**Attachment 4: DPO Comment, Applicant Responses, Department Response in  
Proposed Order Crosswalk Tables**

**Attachment 4: Boardman to Hemingway Transmission Line  
DPO Comment, Applicant Responses, Department Response in Proposed Order Crosswalk Tables**

DPO Page #	Idaho Power's Comment	Idaho Power's Proposed Edit	ODOE Evaluation of Comment
<b>Idaho Power DPO Comments: B2HAPDoc8-1 All DPO Comments Combined-Rec'd 2019-05-22 to 08-22 B2HAPP; Doc8-002 DPO Applicant Comment_IPC Stokes 2019-06-20 to 08-22</b>			
Page 4	Typo	For additional discussion of the comparison between the <del>deferral-federal</del> NEPA review and permitting process and the Oregon Energy Facility Siting Council's review and permitting process see section III.A, Transmission Corridor Selection, of this order.	Typo corrected in proposed order.
Page 39	Typo	The applicant proposes four pulling and tensioning sites to include light-duty fly yards. The counties in which the light-duty fly <del>years</del> -yards are proposed to be located are Umatilla, Baker and Malheur counties.	Typo corrected in proposed order.
Page 41	Typo	Under ORS 469.503, to issue a site certificate, the Council shall determine that the pre

Figure 1 – Project Map with Morgan Lake Park Boundary

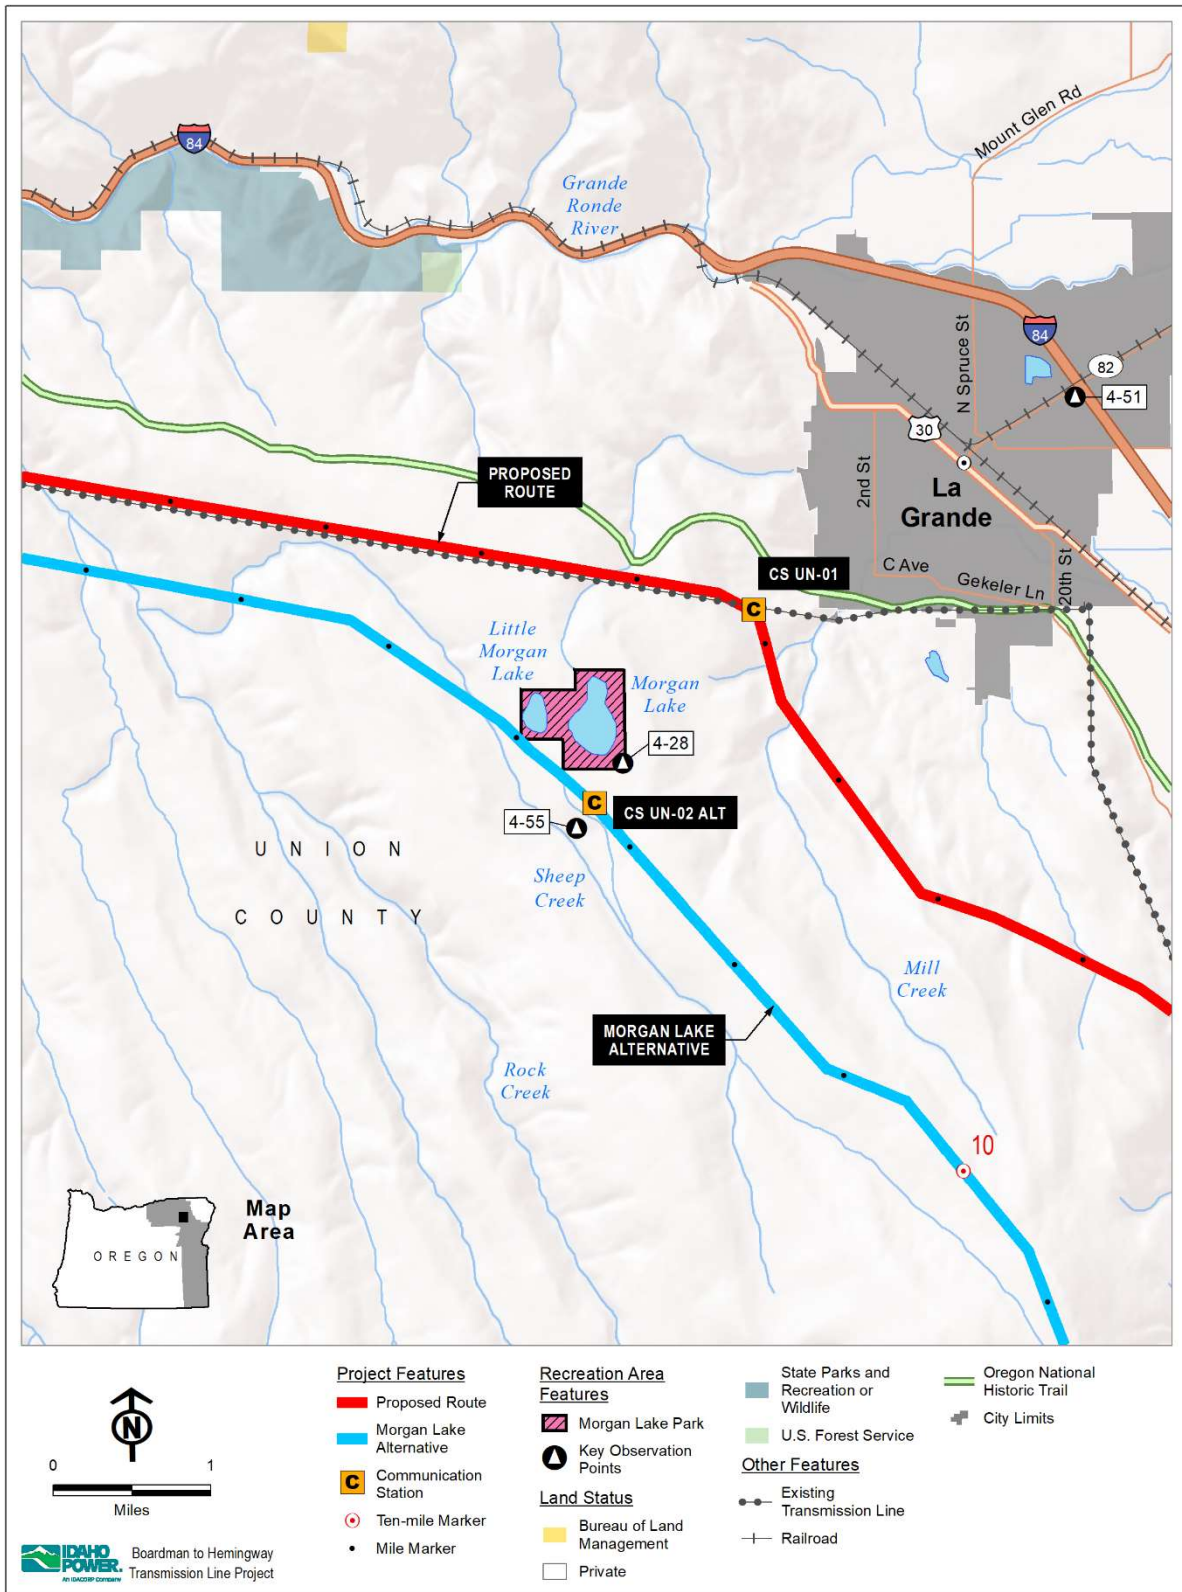
This analysis also assumes that ODOE will require four H-frame towers (ML 7/1, ML 7/2, ML 7/3, and ML 7/4), which are the towers passing closest to Morgan Lake Park per ODOE's Recommended Recreation Condition 1 and Idaho Power's August 22, 2019 DPO Comments. Figure 1 shows the location of Morgan Lake Park with respect to the Morgan Lake Alternative.

Figure 3 – Viewshed of ML 8/2

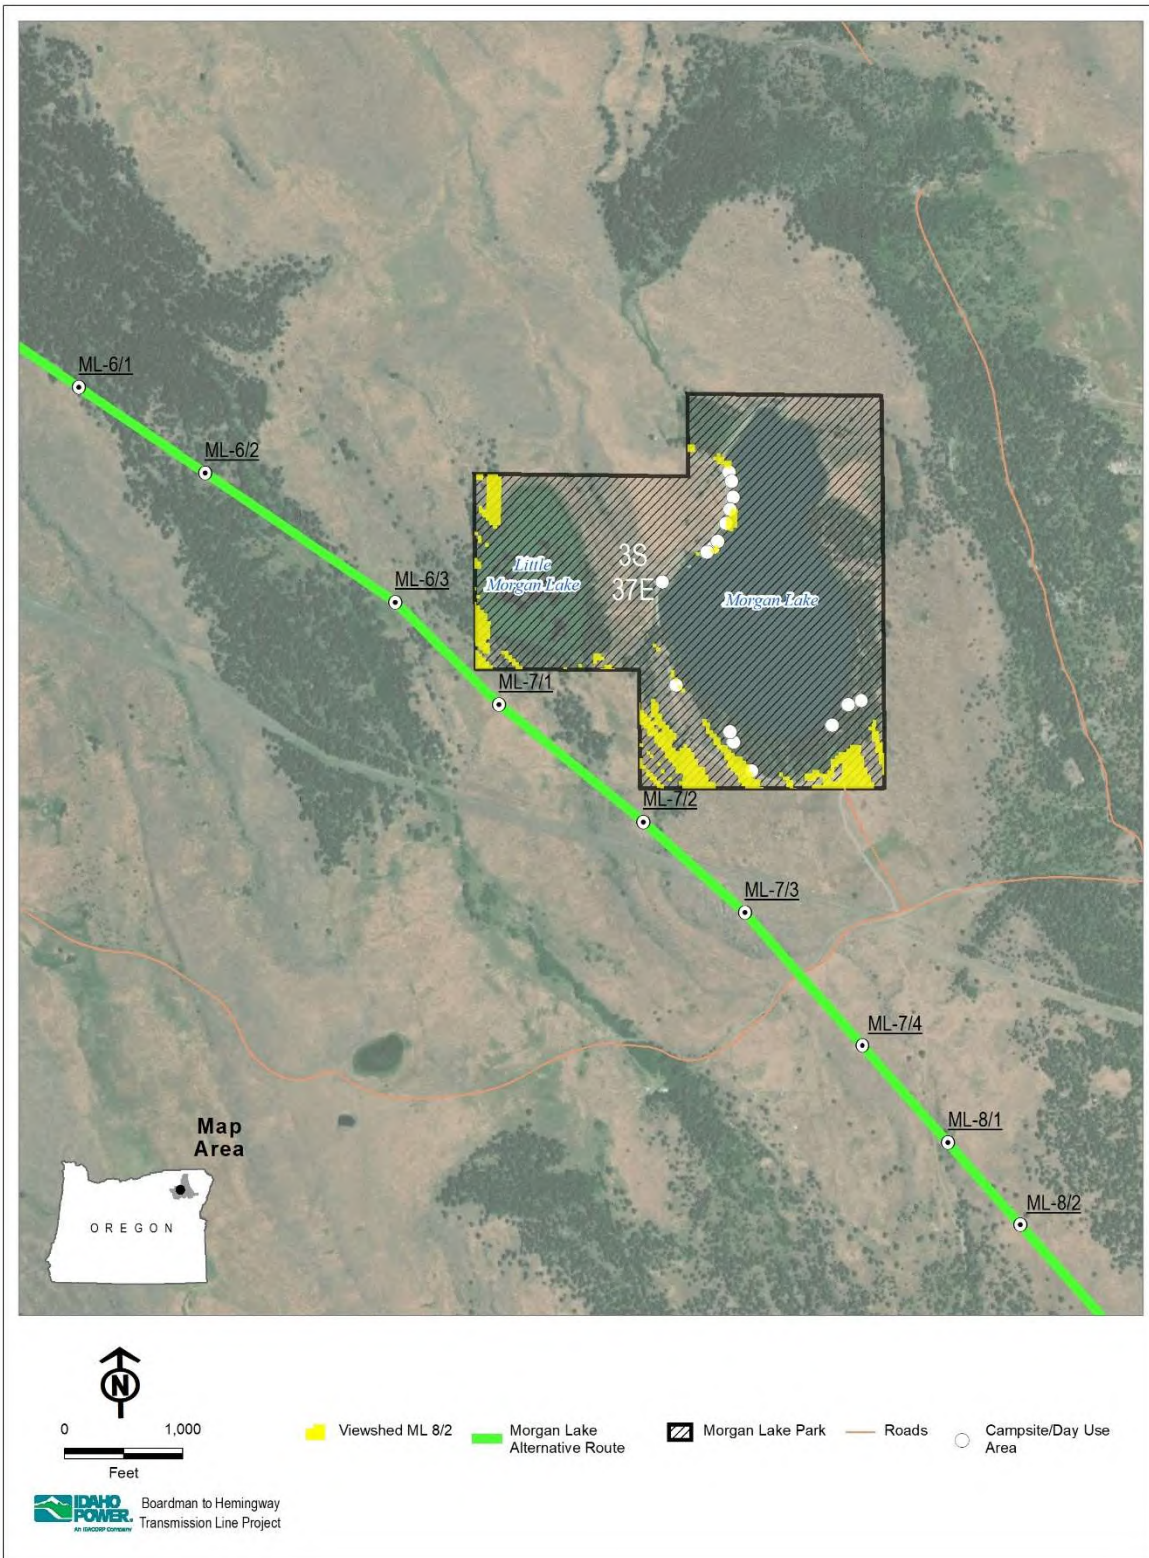
Around Morgan Lake, vegetation would effectively screen views of the transmission towers except for a few discrete locations along the western shore. No towers would be visible from the floating dock (see Figure 3 and Figure 8). Towers would not be visible from the campsites themselves along the southern shore of Morgan Lake, although the towers would be visible from the campsite parking areas.

Figure 5 – Viewshed of ML 6/1 - 6/3, 7/1 - 7/4, 8/1 - 8/2

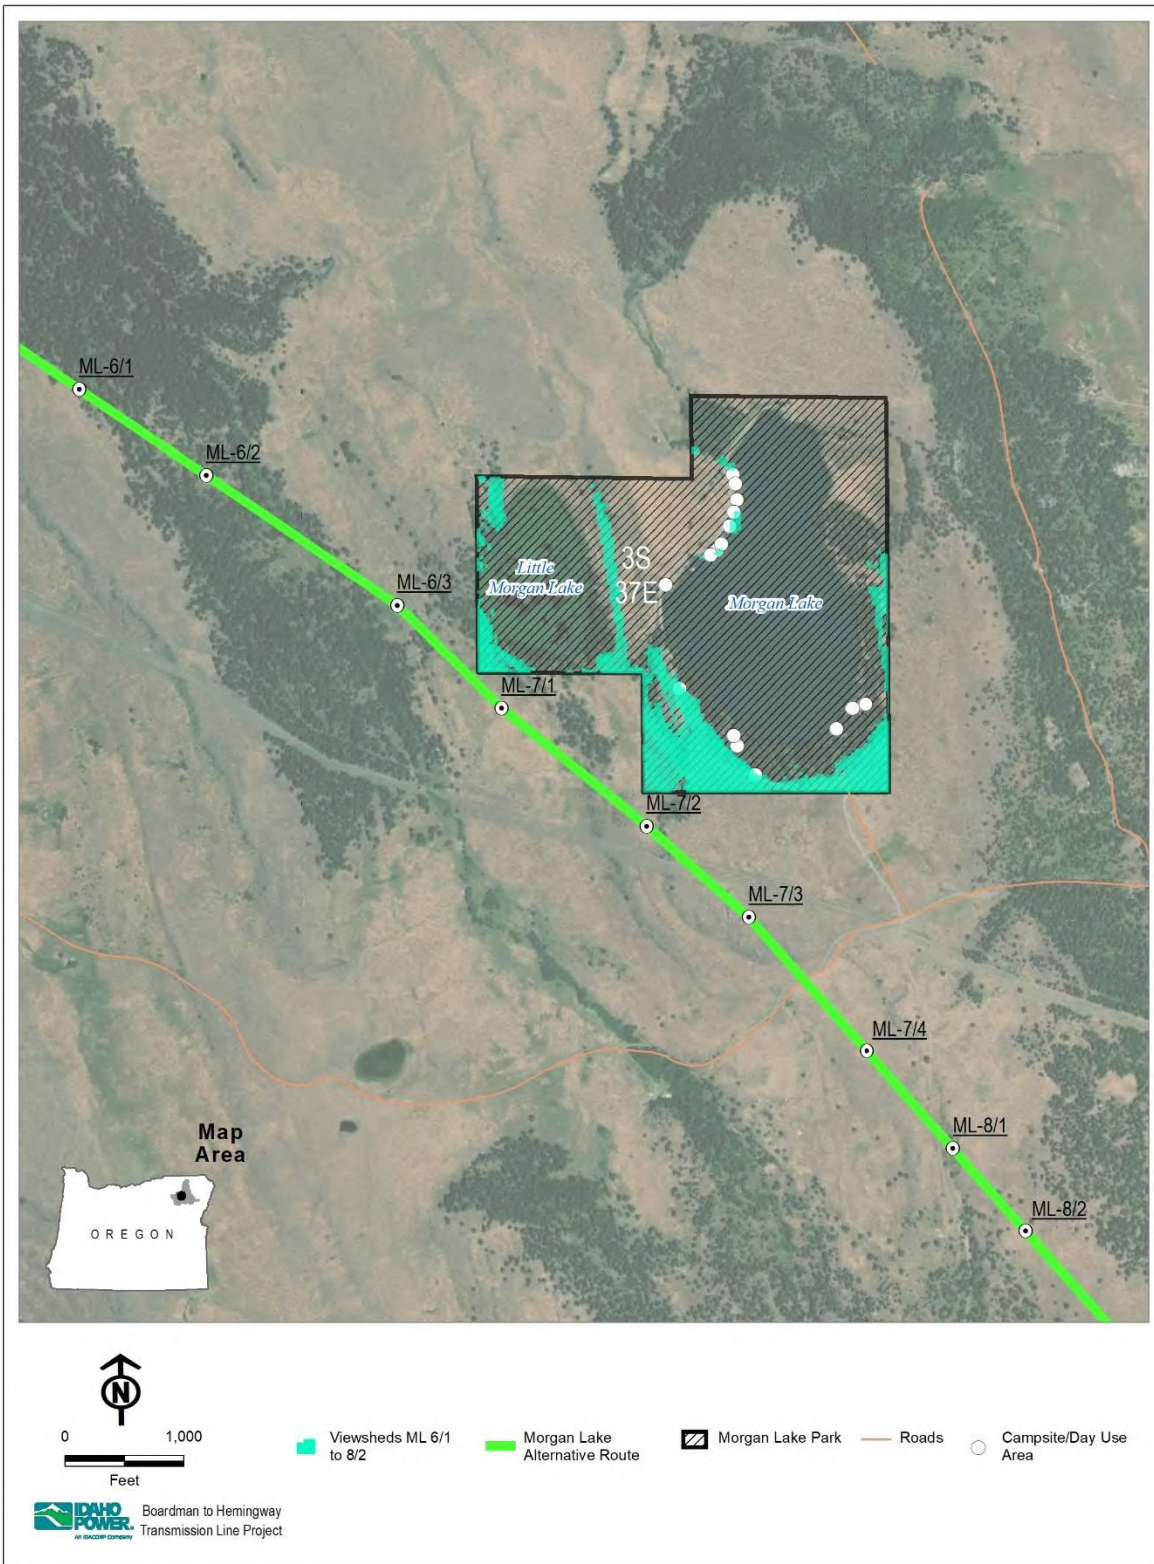
Figures 5 and 6 show the modeled viewshed accounting for trees surrounding Morgan Lake and Little Morgan Lake for the following towers nearest to Morgan Lake Park: ML 6/1, ML 6/2, ML 6/3, ML 7/1, ML 7/2, ML 7/3, ML 7/4, ML 8/1, and ML 8/2. Light green shading depicts areas within the Morgan Lake Park boundary where at least some portion of one of the above listed transmission towers would be visible.
